**NUMBER:** 23-016-21**GROUP:** 23 - Body**DATE:** April 22, 2021

Water Leaks At Sliding Backlite

2019 - 2020 (DT) RAM 1500 Pickup

**Fig. 1**  
**Inside Truck Cab**

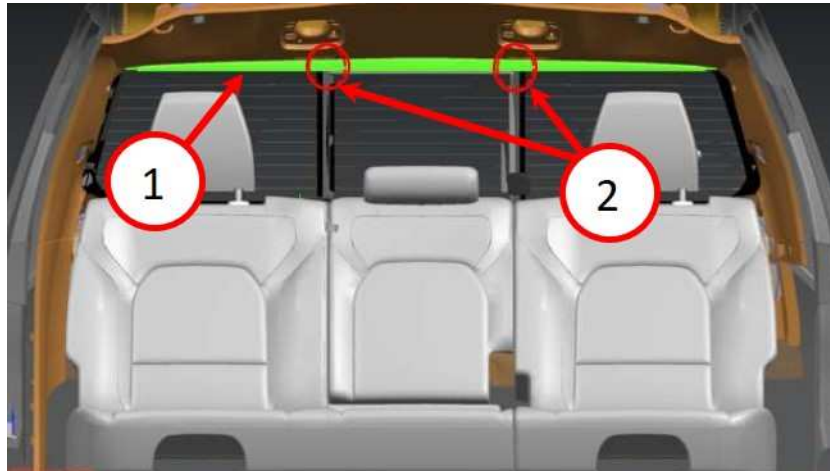
1. Inspect the rear sliding glass assembly from inside the cab, looking for cracks in the frame (Fig. 1) .

- 1 - Upper Plastic Frame of Rear Sliding Glass Assembly (Green Area)
- 2 - Potential Crack Locations
